**RFP 140918**

**TSTC – Housing Exterior Renovations – Phase II – 2014**

**Addendum #2**

**Posted Date: 10-1-14**

Fascia Detail – General Scope Note 10

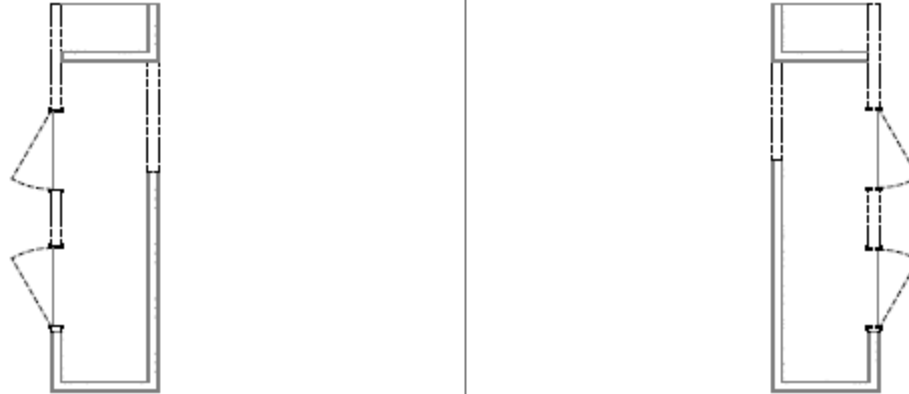
- **Delete the following General Scope Notes:**
  - **7, 8, 9, 13**
- **Revise General Scope Note 10 to read:**
  - **“Replace all fascia 1x trim with specified product. Salvage or replace nose board 2x8 and trim with Hardiboard. Refer to previously improved 301-319 Vance units for standard. See photo on separate page for clarification.”**
- **Add General Scope Note 14 reading “Modify storage sheds per the attached detail.”**
- **Add 1 window unit to be replaced on 421 Vance – North Elevation**
- **Add General Note 11 reading “Previously improved units 301-319 Vance are the standard for this scope of work.”**

- ⑩ Replace all fascia 1x trim with specified product. Salvage or replace nose board and trim with Hardiboard. Refer to previously improved 301-319 Vance units for standard. See photo on separate page for clarification.

Existing or Replaced  
2x8

New 1x2

Painted Hardiboard  
Trim

Typical Detail for Carport Shed Modification on Vance Units

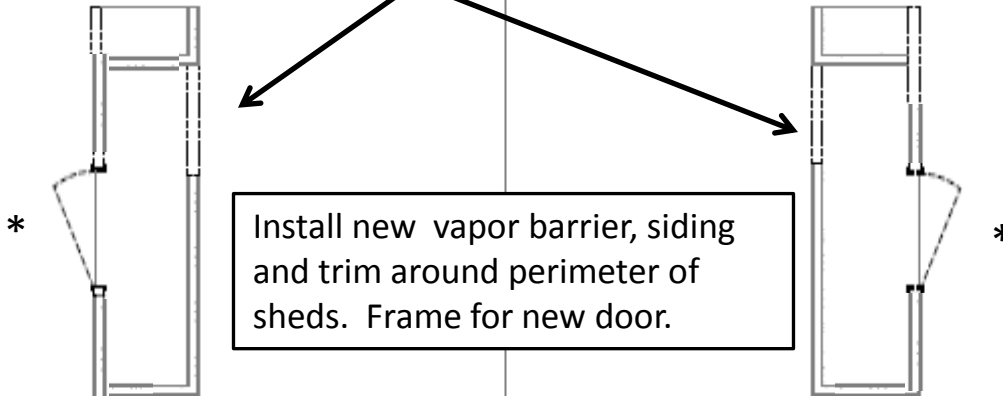
- ⑬ ~~Build out new soffit assembly with specified product. See separate page for detail.~~
- ⑭ Modify storage sheds per the attached detail.

General Scope Note 14

Demo all existing siding, doors, frames.

Install 4 x 16 vent.

Note: Replace 4x4 vertical support posts as needed.

Install new vapor barrier, siding and trim around perimeter of sheds. Frame for new door.

Provide 3'0"x6'8" single bore Residential All Weather Metal Door Unit.

\*Paint new doors  
SW 6148 Wool  
Skein, Exterior Latex  
Semi-Gloss
